MANASQUAN PLANNING BOARD MEETING AGENDA

Re: Boro File No. MSPB-R2110
Variance – Kelly
Block 158, Lot 11
163 McLean Avenue
R-1 Single-Family Residential Zone
Borough of Manasquan, Monmouth County, NJ

Re: Boro File No. MSPB-R2150
Site Plan – 227 East Main St LLC
Block 89, Lot 1
227 East Main Street
BR-1 - Business Retail Zone
Borough of Manasquan, Monmouth County, NJ

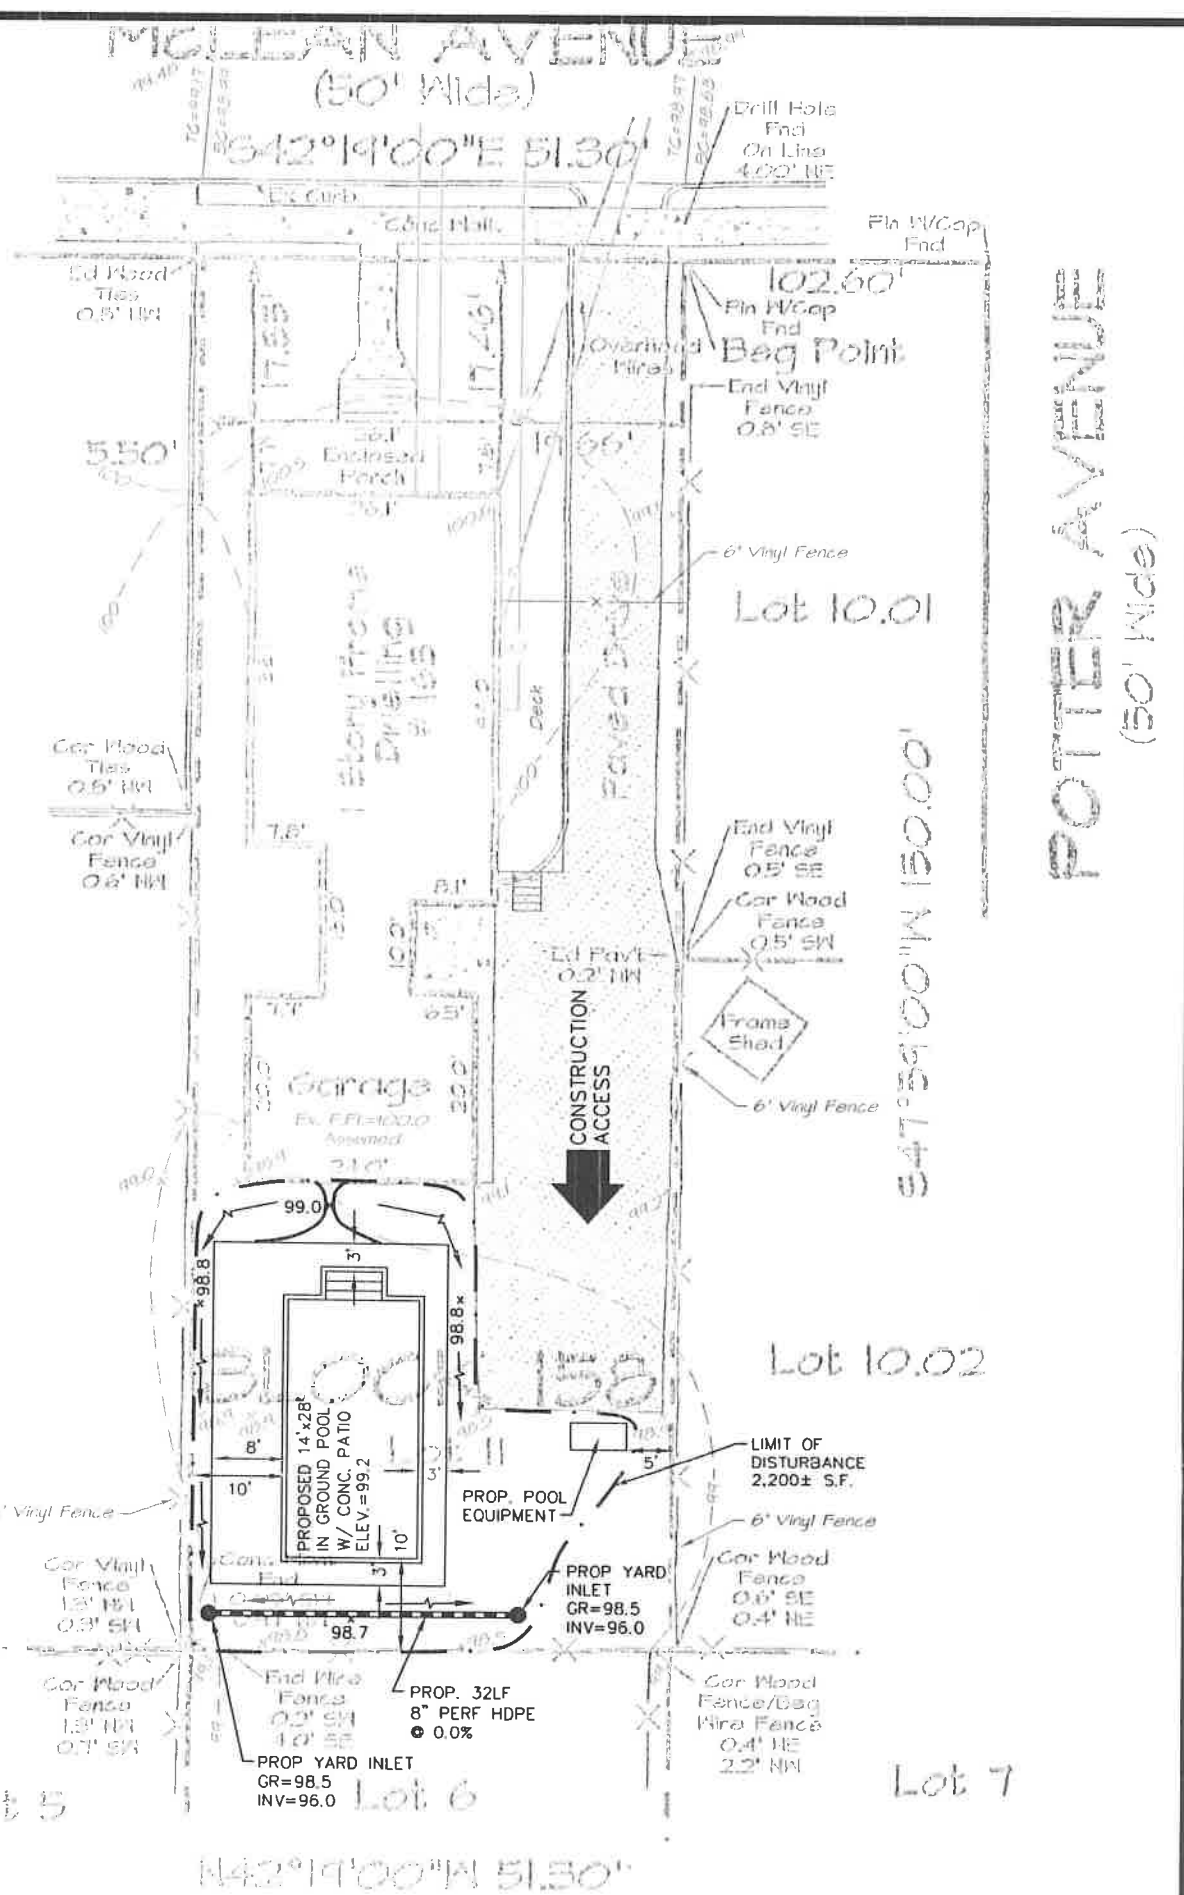
7. The plan provides for a recharge system consisting of two yard inlets and perforated pipe behind the pool and patio. The applicant should be aware that a two-foot separation from seasonal high groundwater must be maintained to the bottom of the proposed system.

LIGHTING & LANDSCAPING PLAN
PRELIMINARY AND FINAL MAJOR SITE PLAN
 227 EAST MAIN STREET
BLOCK 89 - LOT 1
 FOR MICHAEL & CARA ROSE
 BOROUGH OF MANASQUAN
 MONMOUTH COUNTY, NEW JERSEY

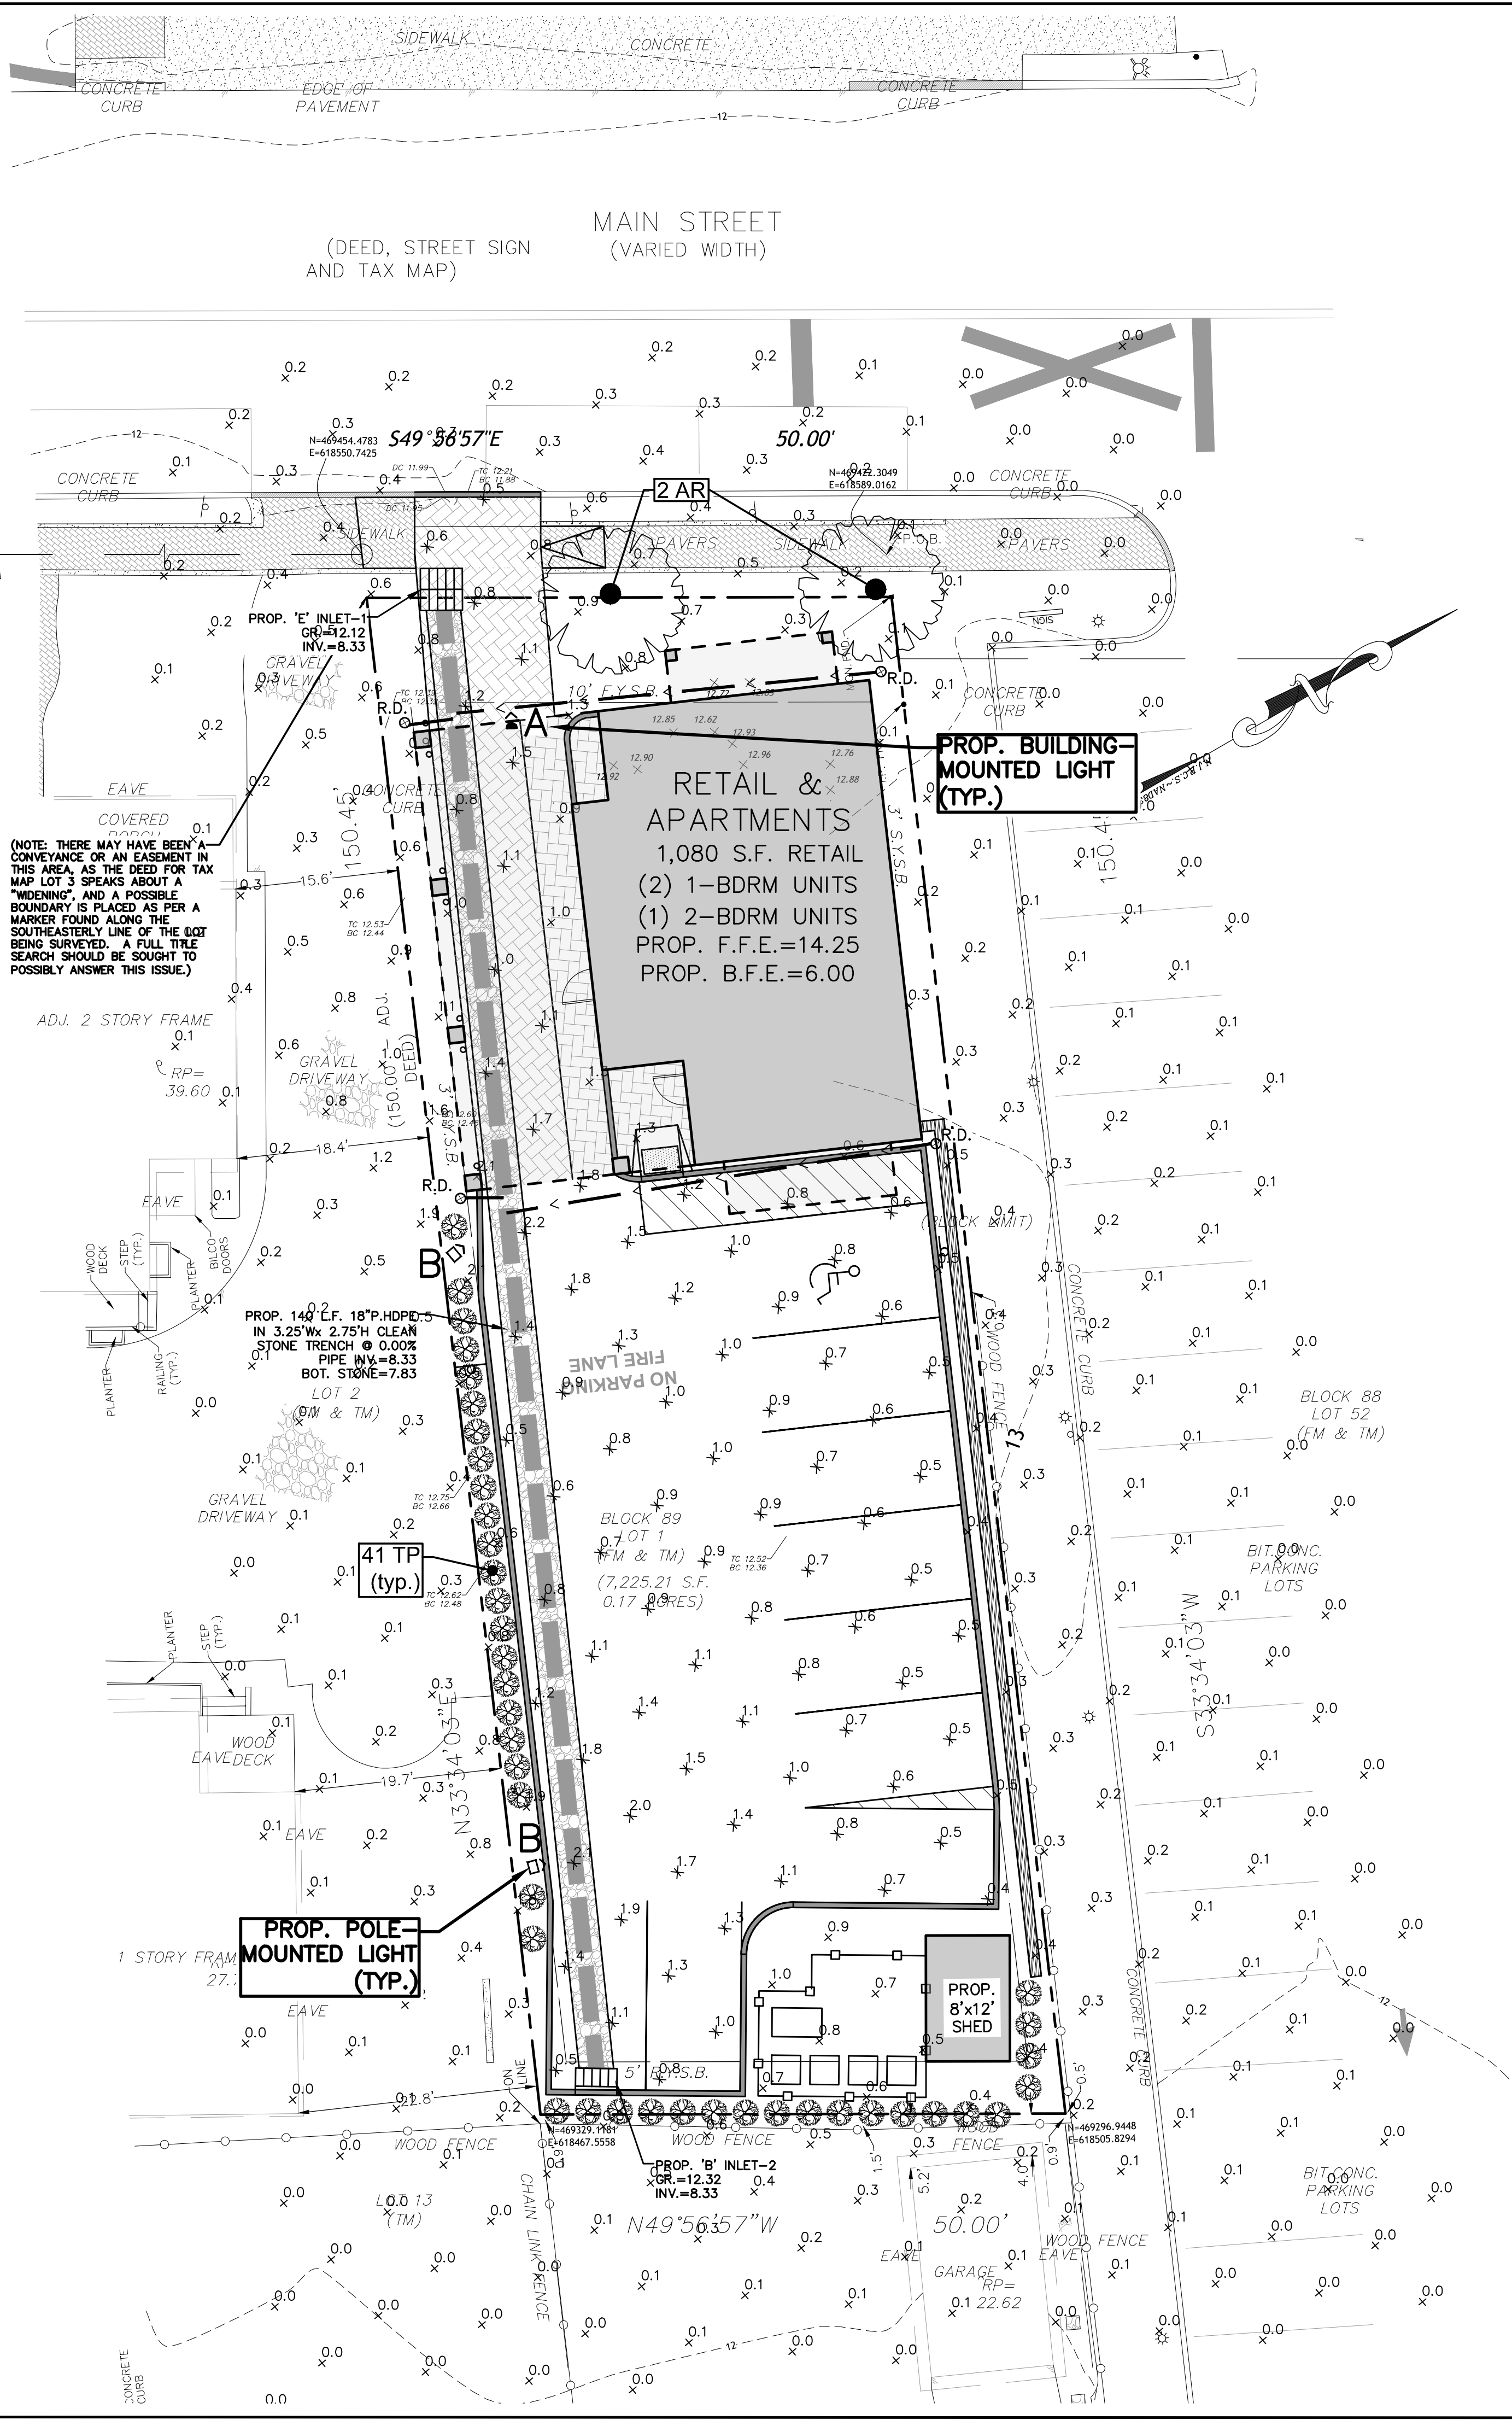
20. Landscaping is required for all parking areas and should be provided along the easterly lot line adjacent to Lot 52.
21. I suggest additional landscaping be provided for the frontage of the site.
22. All existing mature trees should be located on the survey and any trees to be removed must be indicated on the site plan.
23. The proposed parking lot lighting levels meet the minimum ordinance levels, however there is spillage onto adjacent properties. The lights should be adjusted to prevent spillage and all lighting luminaires should be shielded from view of adjacent properties.

IMPERVIOUS PAVEMENT SECTION
N.T.S.

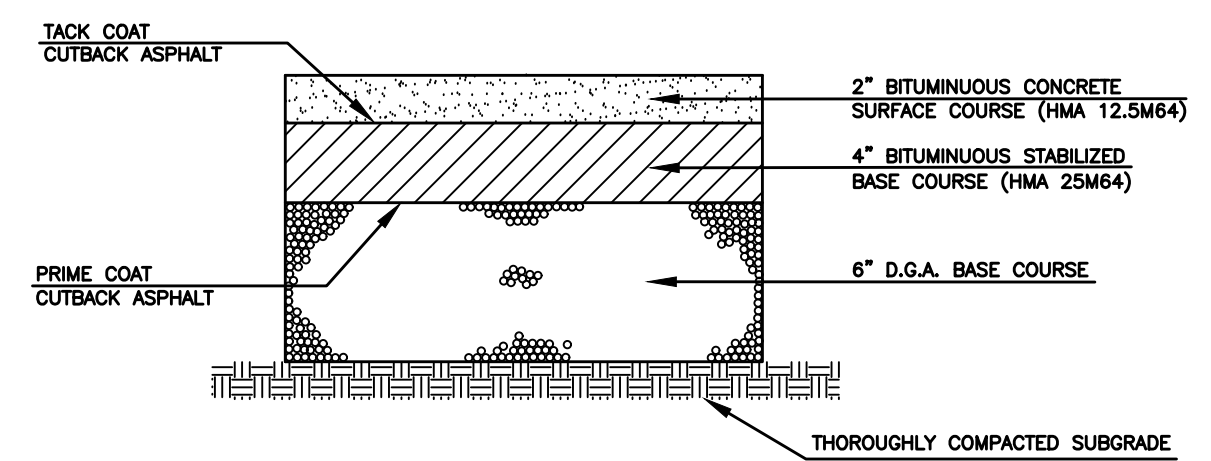
18. A stop sign and stop bar should be provided for the entrance drive at Main Street.
19. A detail for the paver parking area and aisle must be provided.
